TXU Power
Comanche Peak Steam
Electric Station
P. O. Box 1002 (E01)
Glen Rose, TX 76043
Tel: 254 897 5209
Fax: 254 897 6652
mike.blevins@txu.com

CPSES-2000600390
Log # TXX-06038
File # 00236

SUBJECT: COMANCHE PEAK STEAM ELECTRIC STATION (CPSES)
DOCKET NOS. 50-445 AND 50-446
LICENSE AMENDMENT REQUEST (LAR) 06-001
REVISION TO TECHNICAL SPECIFICATION 1.1, "DEFINITIONS"
and 3.4.16, "RCS SPECIFIC ACTIVITY"

ATTACHMENT 1 to TXX-06038
DESCRIPTION AND ASSESSMENT

Figure 3.4.16-1 (page 1 of 1)
Reactor Coolant DOSE EQUIVALENT I-131 Specific Activity
Limit Versus Percent of RATED THERMAL POWER

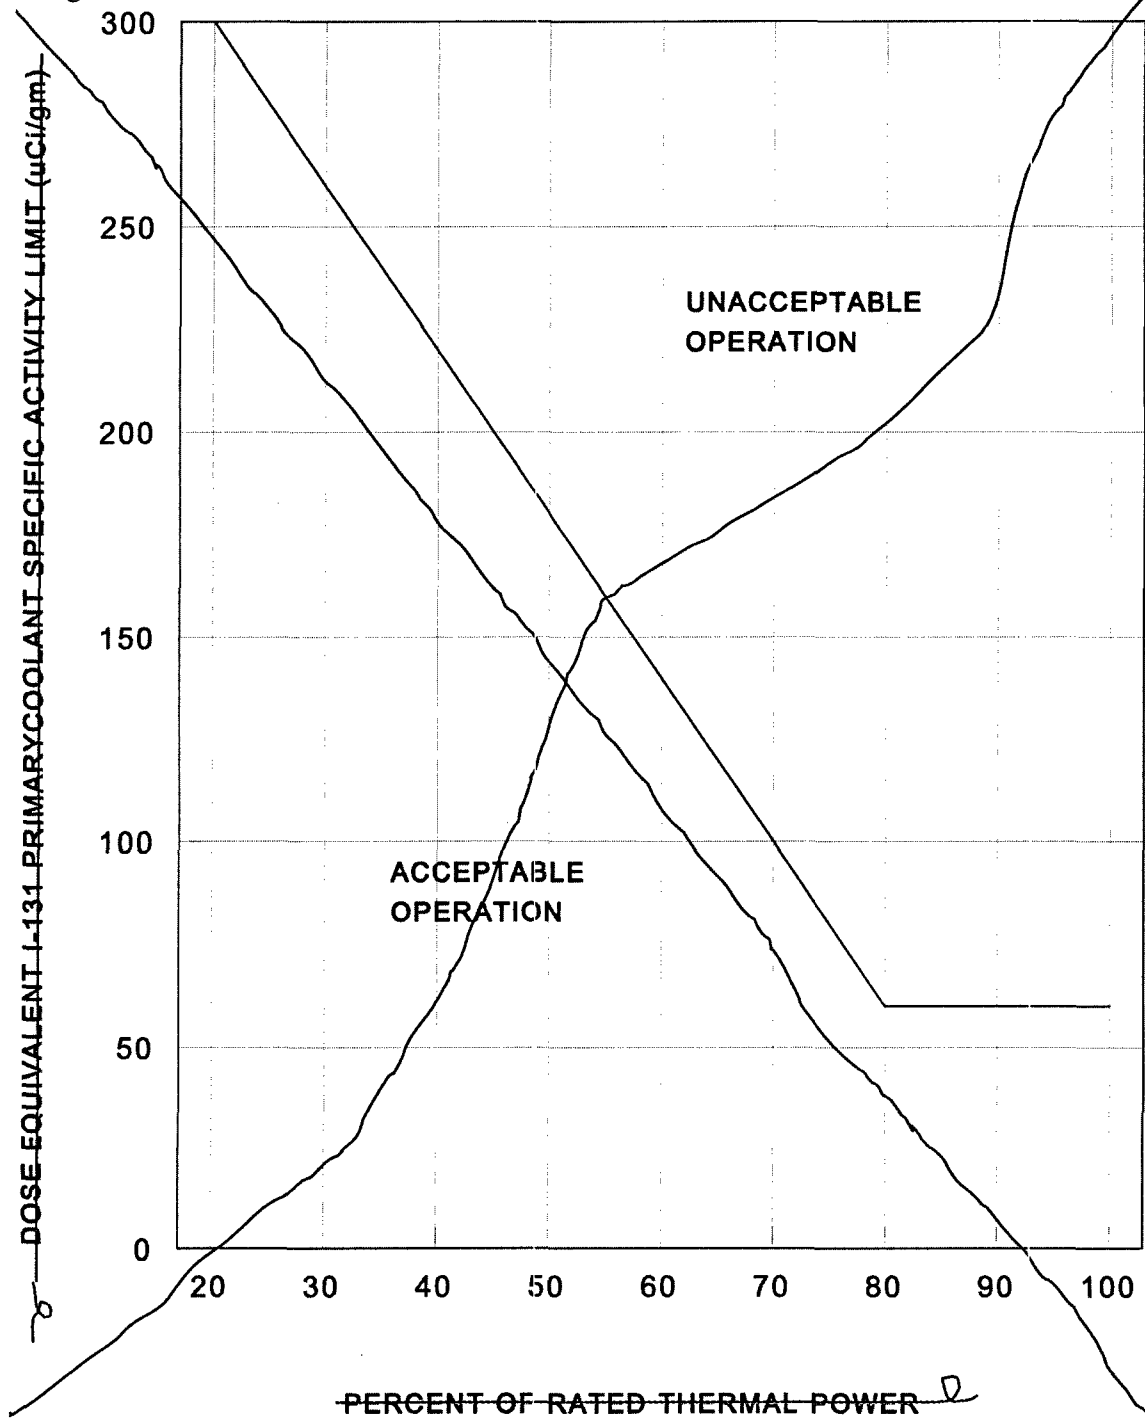
- 2.4 Delete the current TS Figure 3.4.16-1, "Reactor Coolant DOSE EQUIVALENT I-131 Specific Activity Limit Versus Percent of RATED THERMAL POWER".

TS 3.4.16 Required Action A.1 is modified to remove the reference to Figure [3.4.16-1] and insert a limit of less than or equal to 60 $\mu\text{Ci/gm}$ for DEI.

The curve contained in Figure [3.4.16-1] was initiated by the AEC in a June 12, 1974 letter from the AEC on the subject, "Proposed Standard Technical Specifications for Primary Coolant Activity." However, this letter does not provide any technical basis for the curve.

The Case 2 radiological consequence analyses for SGTR and MSLB accidents that take into account the pre-accident iodine spike do not consider the elevated RCS iodine specific activities permitted by current TS Figure [3.4.16-1] for operation at power levels below 80% RTP (i.e., DEI of 60 $\mu\text{Ci/gm}$ at 80% RTP increasing linearly to [300] $\mu\text{Ci/gm}$ at [20]% RTP). Instead, the Case 2 analyses assume a DEI concentration 60 times higher than the corresponding accident's Case 1 analysis assumption, [which corresponds to the 60 $\mu\text{Ci/gm}$ specific

activity limit associated with 100% RTP operation as discussed in Section 3.1 above.] Therefore, TS 3.4.16 Required Action A.1 should be based on a limit of 60 $\mu\text{Ci/gm}$ to be consistent with the assumptions contained in the radiological consequence analyses. It is not expected that plant operation at reduced power levels would result in iodine specific activity levels that exceed the 60 $\mu\text{Ci/gm}$ upper limit defined for full power operation.
